6.3 6-8 BOUNDARY STREET, SOUTH MELBOURNE - PSA C204 PORT

LOCATION/ADDRESS: 6-8 BOUNDARY STREET, SOUTH MELBOURNE

- 1.1 To provide a Council position on a request for a Planning Scheme Amendment Application to the Minister for Planning C/- Department of Environment Land, Water and Planning (the Department) for Planning Permit Application Number C204port, 6-8 Boundary Street, South Melbourne.

Figure 3: Light courts at 10-16 Boundary Street

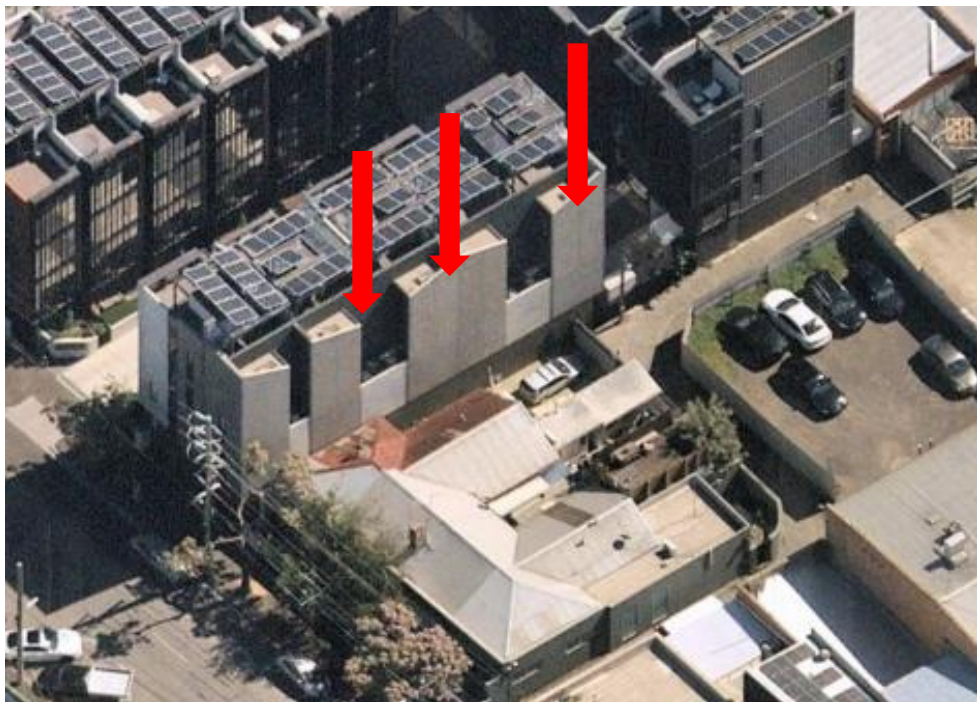
To the north-east, the development at nos. 10-16 Boundary Street provides three light courts at Levels 2 and 3 along the common boundary. The proposed development does not seek to replicate these and would construct a wall on the adjacent boundary.

Pre-application plans sought to provide 1.5m setbacks to the lightwells. These however would not comply with the requirements of DDO30. Council officers advised they generally supported a variation to accommodate a 1.5m setback in this instance.

Council officers also noted that a 5m side setback could be provided on site where the dwelling typology was amended to duplexes for the upper floor levels. The latter option would allow for the location of an access core and lobby area centrally to the site and would remove the requirement for a long corridor at ground floor level. A centralised core would also allow appropriate ramping to provide DDA compliant access from both Boundary Street and the rear laneway.

Notwithstanding the above pre-application advice, the applicant has sought to provide a design response which would be fully compliant with the side setback requirements of the DDO. In this regard, consideration must be given to the resultant amenity impacts to the affected rooms along the boundary at 10-16 Boundary Street and whether an appropriate level of internal amenity would be provided for the future residents of the proposed development.

In summary, the proposal is considered appropriate in this instance and would incorporate a site responsive design by incorporating an internal light court of dimensions that would occupy nearly a third of the site width without burdening the adjoining development site to replicate the same design response. The proposed apartments would rely on this internal light court for natural light and ventilation, ensuring that if adjoining sites are re-developed in future the internal amenity of these apartments would be protected. For this reason, the proposed design response is considered acceptable, subject to recommended conditions.
